SERVICE BULLETIN

EQUIPMENT SERIES: 32S

BULLETIN NO. 4A

EQUIPMENT TYPE: TRANSMITTERS 32S-1, 32S-2

Figure 1. Physical Location of Cathode Follower Components Affected By This Modification.

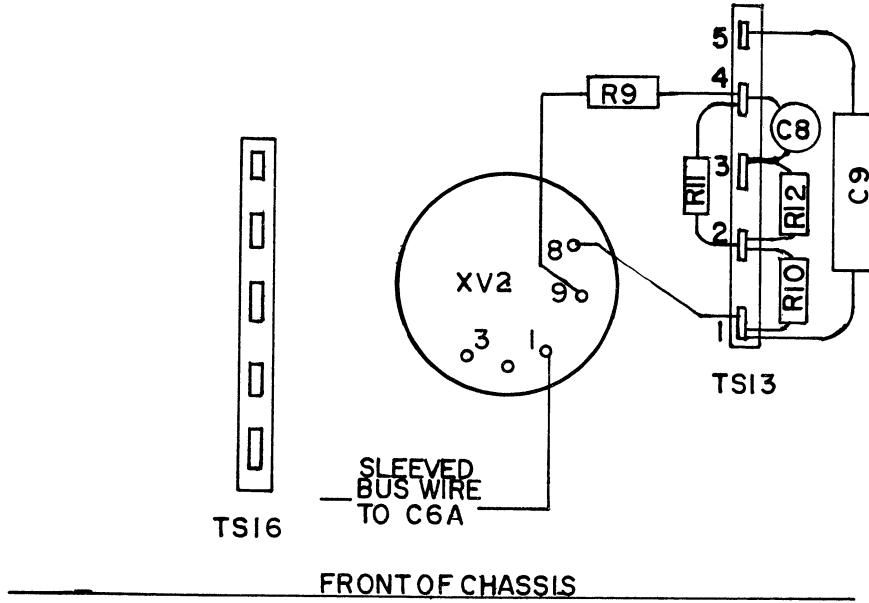
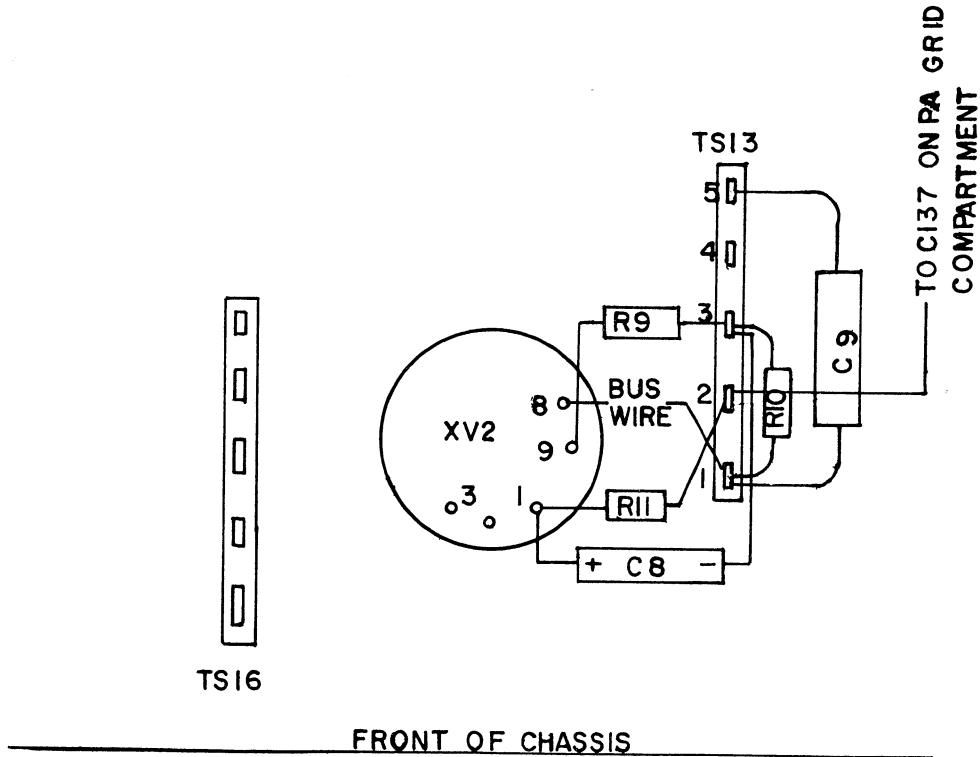
8. Remove 15K-ohm resistor R12 which is connected between terminals 2 and 3 of TS13.
9. Remove 220-ohm resistor R10 which is connected between terminals 1 and 2 of TS13.

10. Remove wire which is connected from pin 1 of tube V2 to (+) side of 8-uf dual-section fixed electrolytic capacitor C6A. This capacitor is located adjacent to the BFO TEST.

11. Install new 10K-ohm resistor R11 (745-3394-00) from pin 1 of tube V2 to terminal 2 of TS13.
12. Install new 4-uf capacitor C8 (183-1783-00) from pin 1 of tube V2 to terminal 3 of TS13 with plus (+) lead connected to pin 1. It might be advisable to check if any possibility exists in which the (+) lead might short out to another component, if so, sleeve lead with insulation removed from lead of old C8.

13. Connect no. 22 AWG red (439-7068-00) from terminal 2 of TS13 to feed-through capacitor, C137, on PA grid compartment.
14. Install new 1K-ohm resistor R10* (745-1352-00) between terminals 1 and 3 of TS13.

15. Disconnect lead of 220K-ohm resistor R9 which is connected to terminal 4 of terminal strip TS13 and reconnect to terminal 3 of TS13. (The other end of R9 is connected to pin 9 of V2.)

Figure 2. Physical Location of R70 on 32S-1/2 Chassis

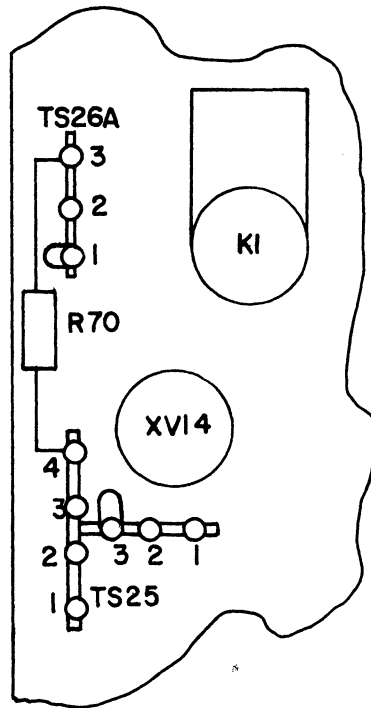
1. Remove Phillips-head screws and four feet from bottom of cabinet.
2. Lift lid and remove the two unpainted Phillips-head screws in the top rim. Slide unit out of cabinet.
3. Turn unit bottom side up with front panel toward operator.
4. Solder a short piece of bus wire across 470K-ohm resistor R70. R70 is located at the left edge of the chassis near relay K1 and soldered between terminal 4 of terminal strip TS25 and terminal 3 of adjacent terminal strip TS26A. (Refer to figure 3.)
